No. EL/3.1.35/2 (brake lever)

MODIFICATION SHEET No. RDSO/2015/EL/MS/0443 Rev. '0', Date 17.09.2015

1.0 Title: Modification for improving the reliability of motor supports in bogie of WAP7/WAG9 locomotives.

Fig -3

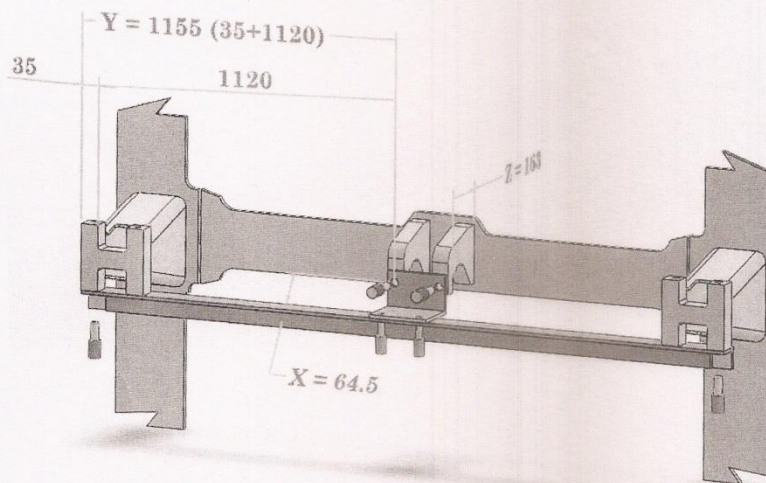
3. Procedure for fixing motor support on bogie transom (4 Nos.):

- Finished modified two nos. motor support to CLW drawing No. 1209-01-412-186 will be tack welded in middle of frame using **tack welding fixture** maintaining distance shown in Fig- 3.
 - 1. X dir. 64.5 mm
 - 2. Y dir. 1155 mm (35+1120)
 - 3. Z dir. 163 mm
 - 4. Sequential Mig welding will be carried slowly using **heavy duty Welding Fixture** so that distance is arrested and dimensional accuracy with centre line is maintained in X, Y, Z, direction.

Fig-4

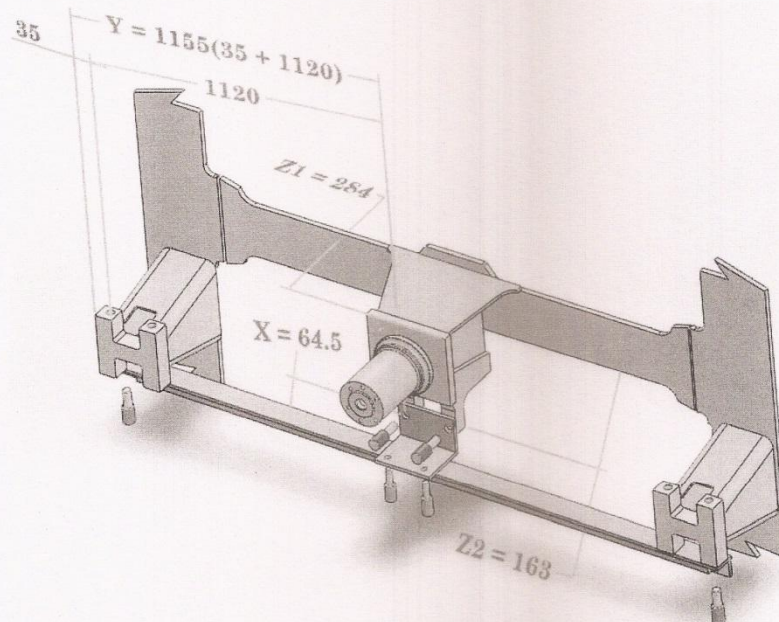
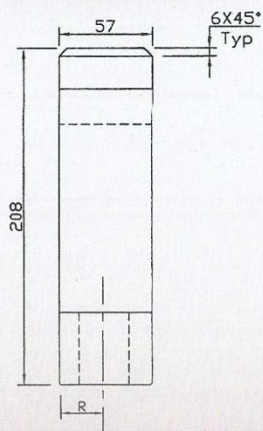
4. Procedure for fixing pivot support sub – assembly with modified motor support as per CLW drawing No. 1209-01.412-187:-

➤ Pivot support sub assembly with in-built welded pivot pin will be welded with transom after locating its position using **tack welding fixture**, maintaining distance shown in Fig 4.

1. X dir. 64.5 mm
2. Y dir. 1155 mm (35+1120)
3. Z dir. (Z1= 284 mm & Z2 = 163 mm) as shown in fig-4
4. Sequential Mig welding will be carried out slowly to avoid distortion during welding process to maintain dimensional accuracy with centre line in X, Y, Z, direction.

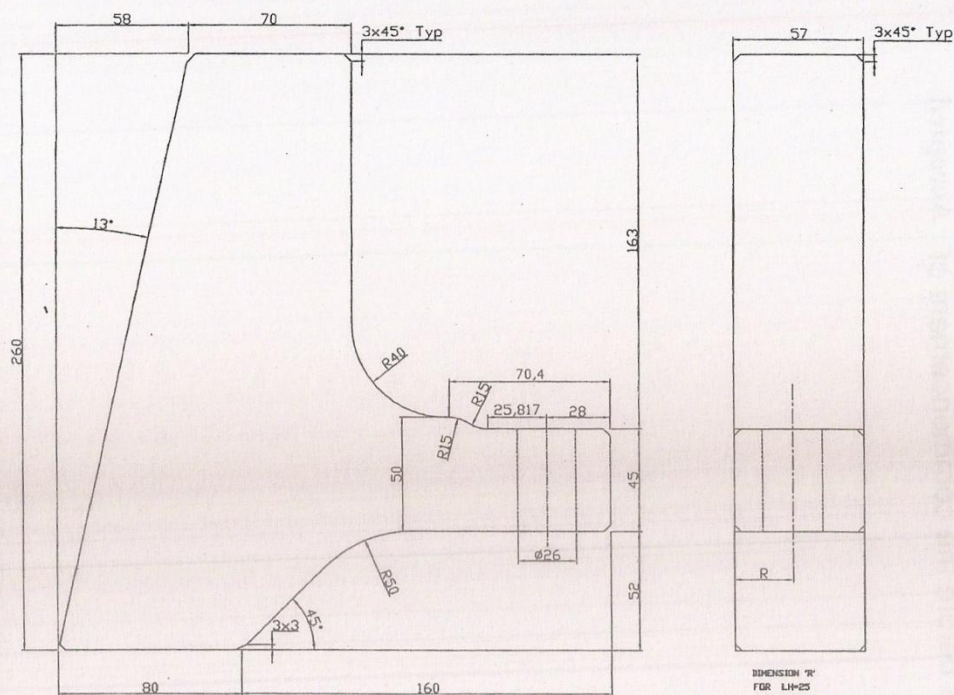
- b. Motor support welded on pivot transom should be maintained as per RDSO SMI No. 280. However, if the sheds are not able to maintain the motor support as per the above SMI, the motor support on pivot transom should be replaced with new motor support as per CLW drawing no. 1209-01.412-187 along with pivot support sub assembly with in-built welded pivot pin.
- c. The procedure for replacement of motor support welded on bogie transom/pivot transom is explained in annexure 'A'.

- NOTE.
- (1). MACHINED ALL OVER Rz 25.
 - (2). ALL DIMENSIONS ARE IN mm.
 - (3). ALL EDGES SHOULD BE CHAMFERED BY 3X45°.
 - (4). ALL FACES SHOULD BE MACHINED "ON CNC".
 - (5). STEP IS NOT PERMITTED AT ANY PLACES.
 - (6). FOR UNSPECIFIED TOLERANCE Ref. IS: 2102 FINE.
 - (7). THIS DRG. SUPERSEDES DRG. NO. 1209-01.412-122.
 - (8). ALL EDGES SHOULD BE SMOOTHENED BY USING GRINDING WHEEL.
 - (9). FINAL PROFILE & DRILL HOLE 26 CAN BE MADE DURING MACHINING TO DRG. NO. 1209-01.112-009.
